APPLICATION NO.	FILING DATE	FIRST NAMED INVENTOR	ATTORNEY DOCKET NO.	CONFIRMATION NO.
10/659,731	09/10/2003	John M. Vincak	10532	3889

Office Action Summary

This is the first office action for application number 10/659,731, Work Stand, filed on September 10, 2003.

Claims 1-7 are rejected under 35 U.S.C. 102(b) as being anticipated by U.S. Patent number 2,675,981 to Ferris.

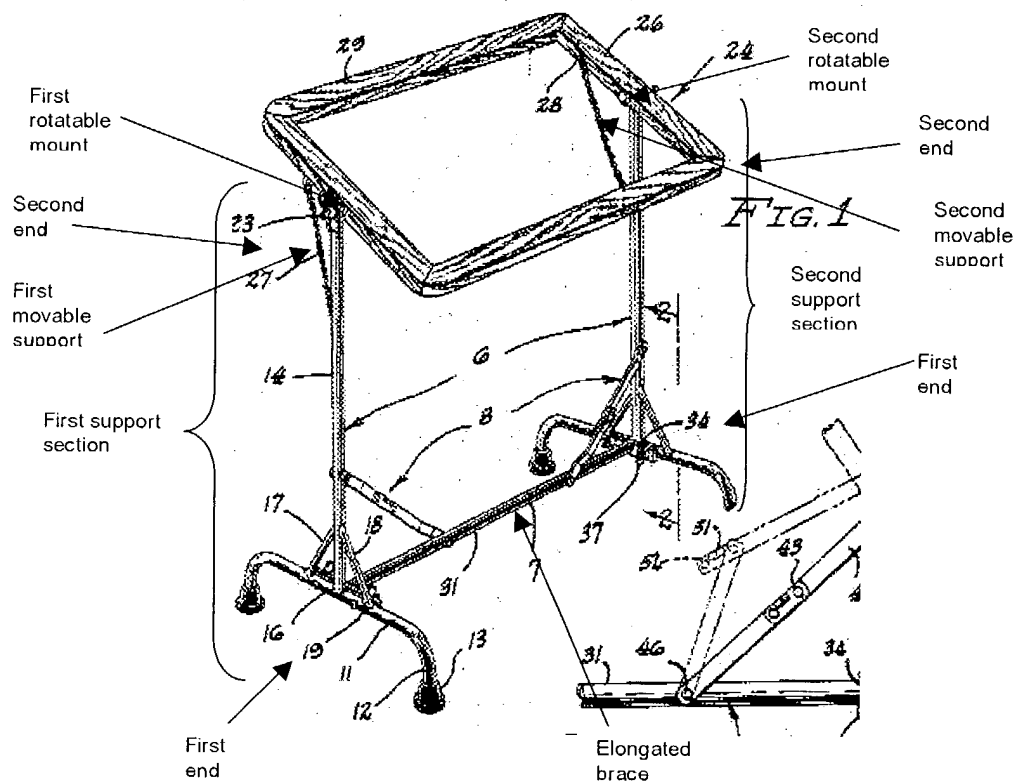
Ferris '981 discloses a stand (above) comprising first and second support sections (above) each having first and second ends, a first rotatable mount (above) disposed upon the first support section proximate to the second end thereof ("proximate" is defined in Merriam Webster's Collegiate Dictionary - 10th Edition as being "close," so clearly, the first rotatable mount is disposed "close" to second end of the first support section; further, all subsequent uses of the term "proximate" in this office action will use the same meaning, and all features being compared as "proximate" are clearly "close" to one another), a second rotatable mount (above) disposed upon the second support section proximate to the second end thereof, an elongated brace (above) having a first end (left end of elongated brace above) attached to/disposed on the first support section proximate to the first end thereof and a second end (right side

of elongated brace above) attached to/disposed on the second support section proximate to the first end thereof, a first movable support (above) disposed upon the first support section proximate to the first rotatable mount and beneath the first rotatable support, a second movable support (above) disposed upon the second support section proximate to the second rotatable mount and beneath the second rotatable mount.

Claims 1-4 and 10-12 are rejected under 35 U.S.C. 102(b) as being anticipated by U.S. Patent number 5,046,203 to de Cuadros.

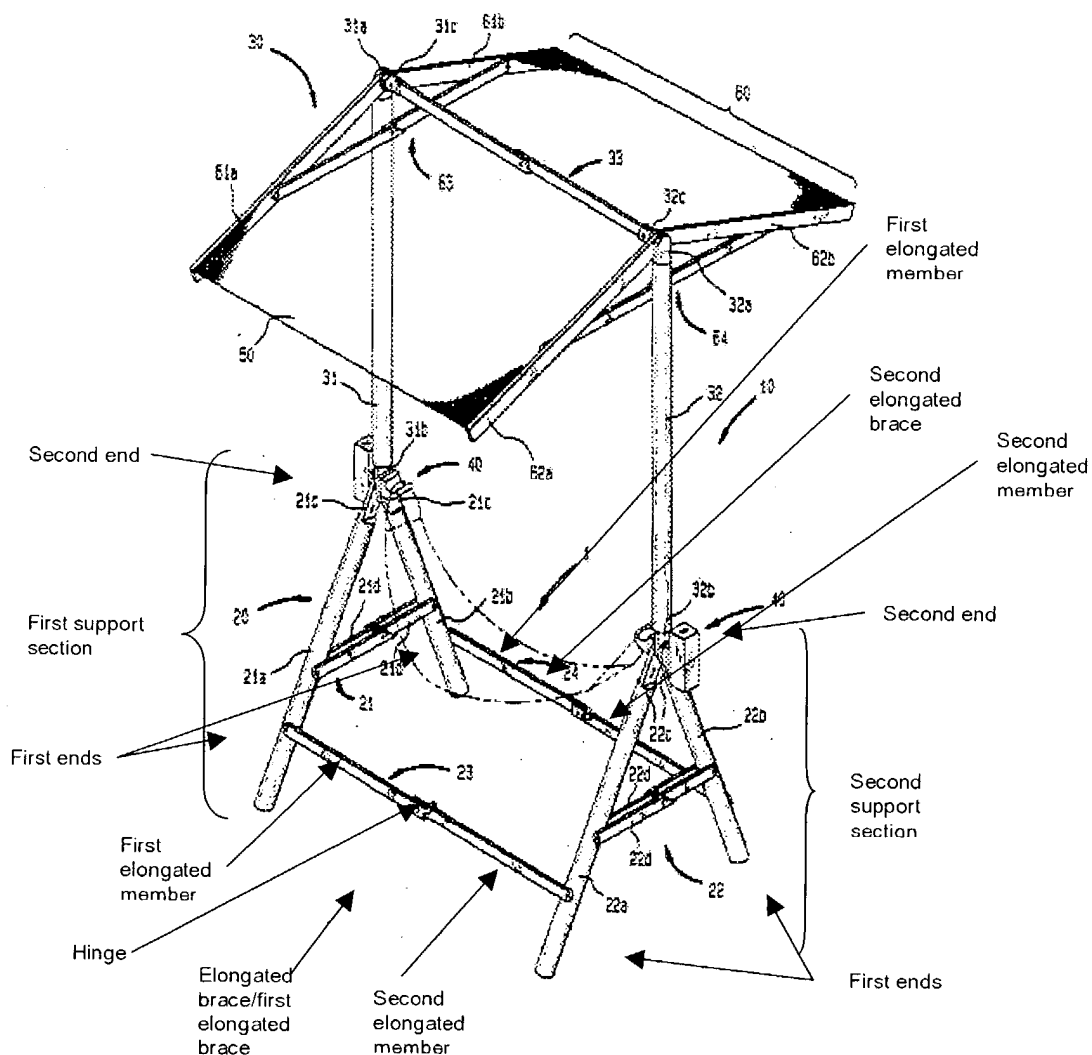
Regarding claims 1-4, 10 and 11, de Cuadros '203 discloses a stand (above) comprising first and second support sections (above) each having first and second ends, a first rotatable mount (41, it can rotate about the threads) disposed upon the first support section proximate to the second end thereof, a second rotatable mount (41, it can be rotated about the threads) disposed upon the second support section proximate to the second end thereof, an elongated brace (above) having a first end (left end of elongated brace above) attached to/disposed on the first support section proximate to the first end thereof and a second end (right side of elongated brace above) attached to/disposed on the second support section proximate to the first end thereof, wherein the elongated brace further comprises a first elongated member (above) having first and second ends (left and right sides respectively, above), and a second elongated member (above) having first and second ends (right and left sides respectively, above), whereby the first end of the first elongated member is pivotally attached to the first support section proximate to the first end of the first support section, the first end of the second elongated member is pivotally attached to the second support section proximate to the first end of the second support section, and the second end of the first elongated member is pivotally attached to the second end of the second elongated member, wherein a hinge (above, 33f, see column 3, lines 35-52).

Further, regarding claim 12, de Cuadros '203 teaches the first support section to have first and second legs (21a,21b) each having first and second ends (above), wherein the second ends of the first and second legs are substantially together and the first ends of the first and second legs are substantially apart, and the second support

section to have first and second legs (22a,22b) each having first and second ends (above), wherein the second ends of the first and second legs are substantially together and the first ends of the first and second legs are substantially apart,

wherein the stand further includes a first support brace (21d) having a first end connected to the first leg of the first support section proximate to the first end of the first leg of the first support section, and the second end of the first support brace is connected to the second leg of the first support section proximate to the first end of the second leg of the first support;

wherein the stand includes a second support brace (22d) having a first end connected to the first leg of the second support section proximate to the first end of the first leg of the second support section, and the second end of the second support brace is connected to the second leg of the second support section proximate to the first end of the second leg of the second support section;

wherein the above mentioned elongated brace is a first elongated brace, wherein the first elongated member of the first elongated brace has a first end pivotally attached to the first leg of the first support section proximate to the first end of the first leg of the first support section, wherein the first end of the second elongated member of the first elongated brace is pivotally attached to the first leg of the second support section proximate to the first end of the first leg of the second support section, and the second end of the first elongated member of the first elongated brace is pivotally attached to the second end of the second elongated member of the first elongate brace,

wherein the stand further includes a second elongated brace (above), wherein a first elongated member of the second elongated brace has a first end pivotally attached to the second leg of the first support section proximate to the first end of the second leg of the first support section, wherein the first end of a second elongated member of the second elongated brace is pivotally attached to the second leg of the second support section proximate to the first end of the second leg of the second support section, and the second end of the first elongated member of the second elongated brace is pivotally attached to the second end of the second elongated member of the second elongate brace.
